DIXIE-NARCO

Service Bulletin # 199

MODELS: All Adaptable and Serpentine Venders
With Serial Numbers less than 1880001.

SUBJECT: Cover, Coin Return Kit

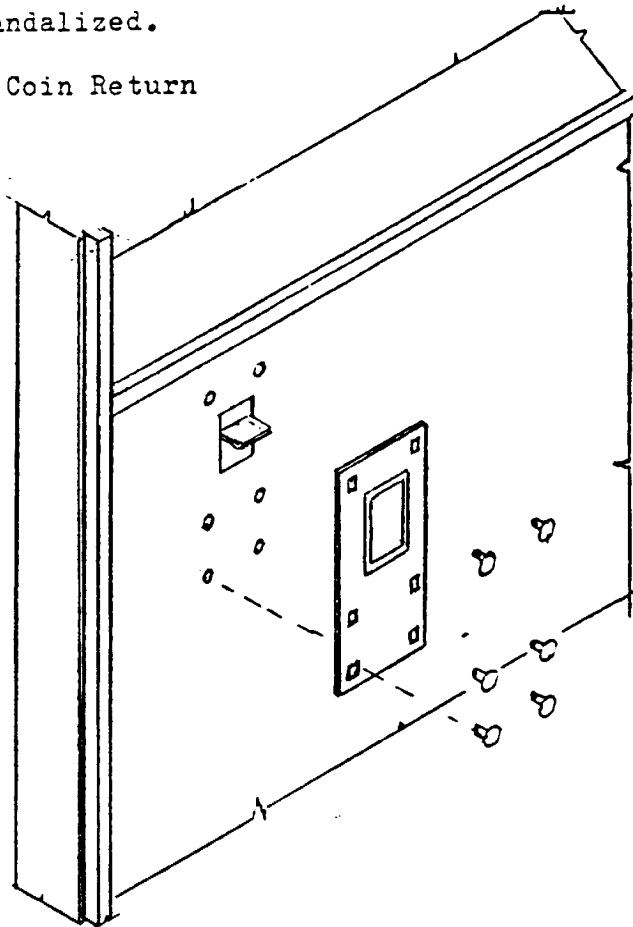
REASON: To provide a cover for the Coin Return Area when the sheet metal is torn and/or vandalized.

1. Remove Frame - Coin Return from Door.
2. Install Frame, Coin Return.
3. Align Hole in cover with coin return hole in door.
4. Using 6 square holes in cover as guide, mark 6 places on door. Drill 6 holes 9/32 diameter.
5. Secure cover to door using 6 carriage bolts with nuts and lockwashers on inside of door.
